Amendment No. 0003
28 February 2002

SUBJECT: Amendment No. 0003 to Specifications and Drawings for Construction of
CN01 REPAIR MFH HOLLY PHASE-1, GRAND FORKS AFB, NORTH DAKOTA
Solicitation No. DACA45 02 B 0005.

Trivers Associates 100 North Broadway Suite 1800 St. Louis, Missouri 63102	Date: 02/26/02	Addendum 3	L-04.1a
	Project #: 2050	[]	
	[]	[]

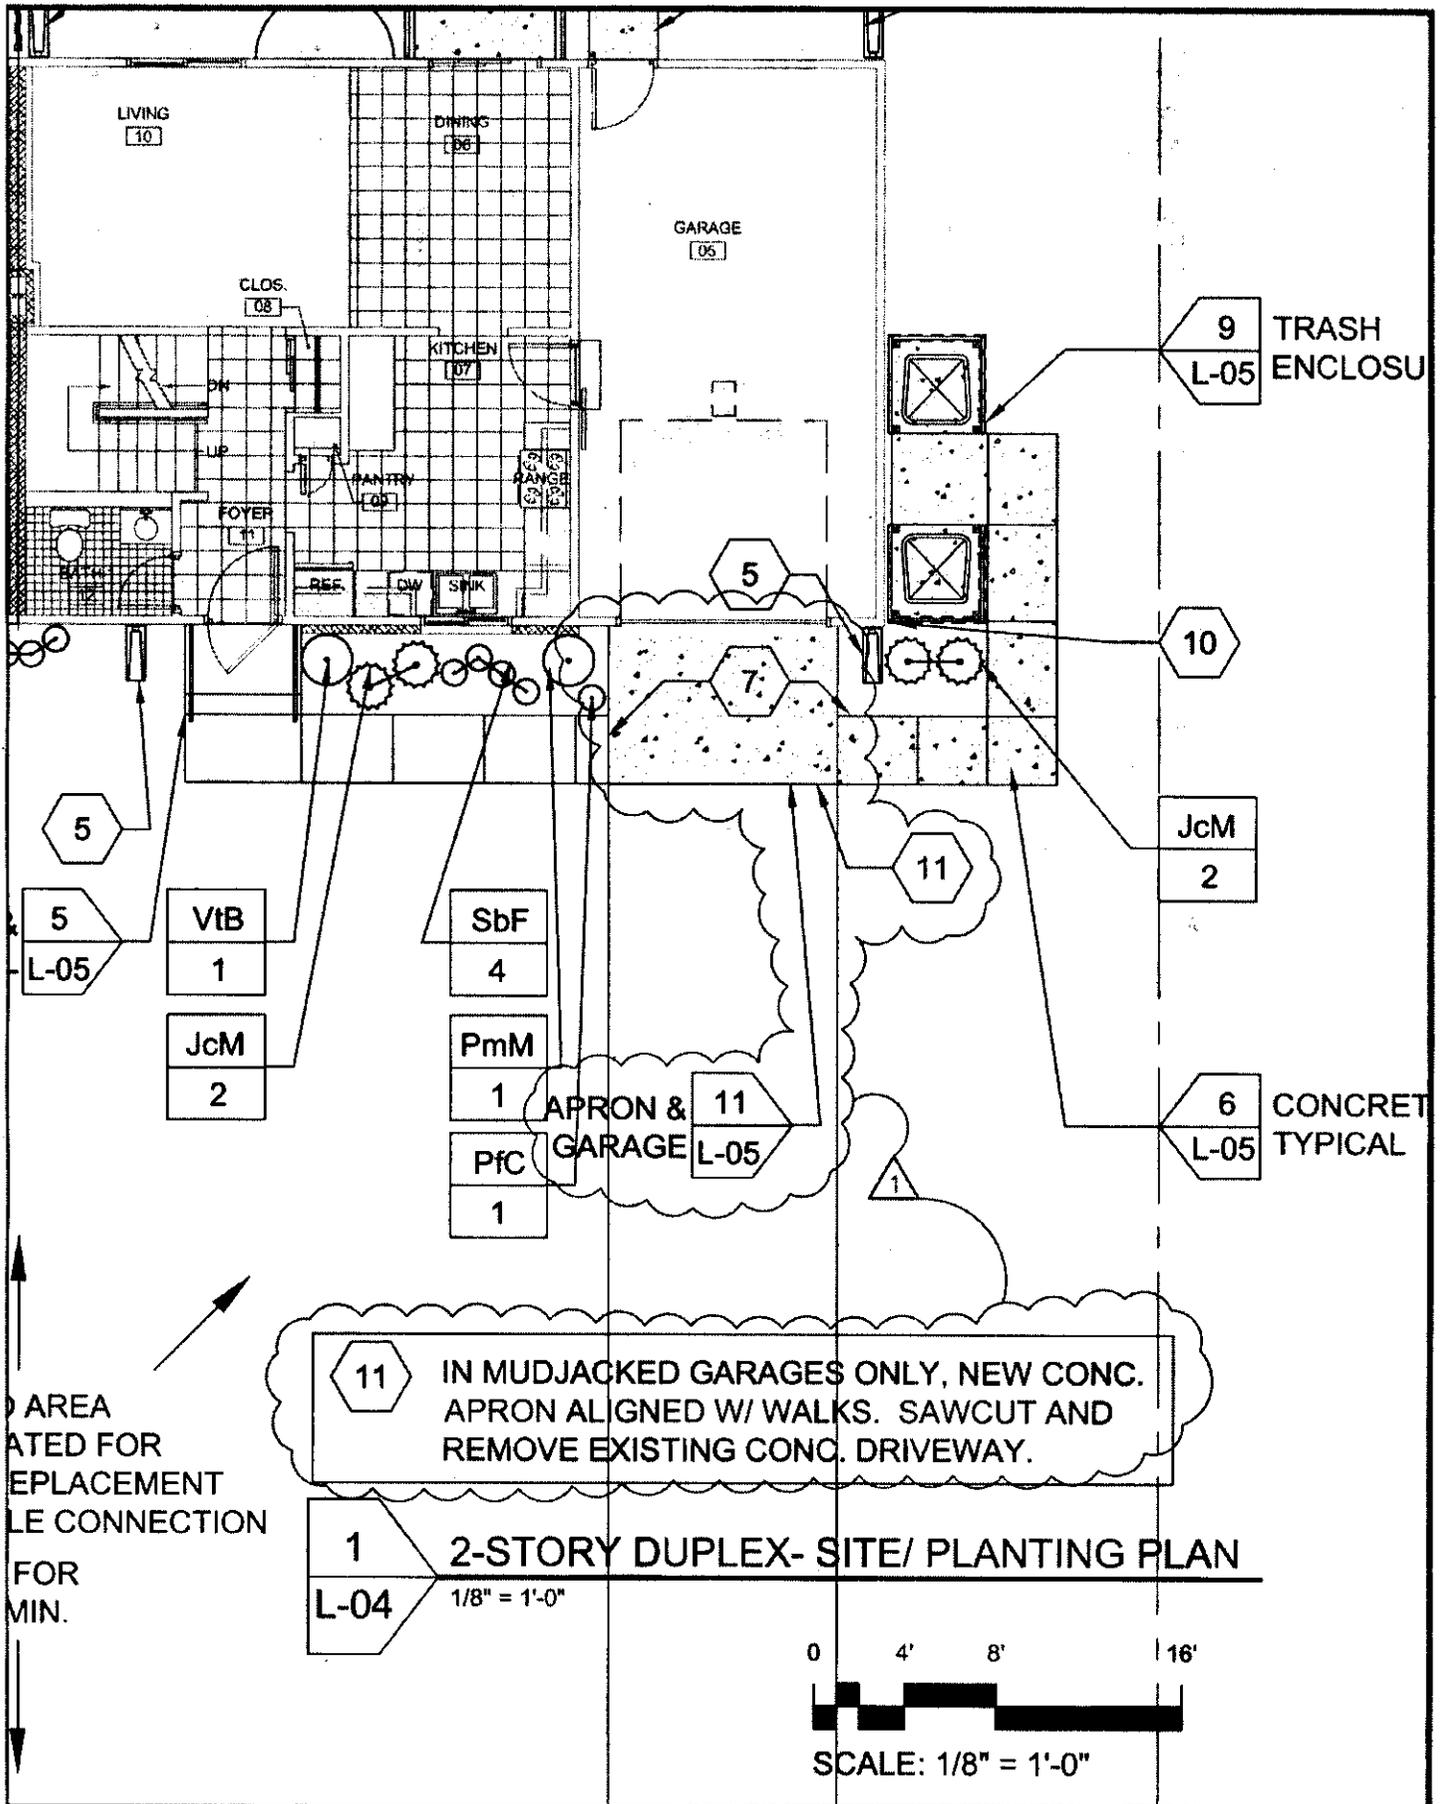
(1) Sheet L-04, 1-STORY DUPLEX-SITE/PLANTING PLAN and 2-STORY DUPLEX- SITE/PLANTING PLAN, revise plans in accordance with attached Sketches L-04.1a and L-04.1b.
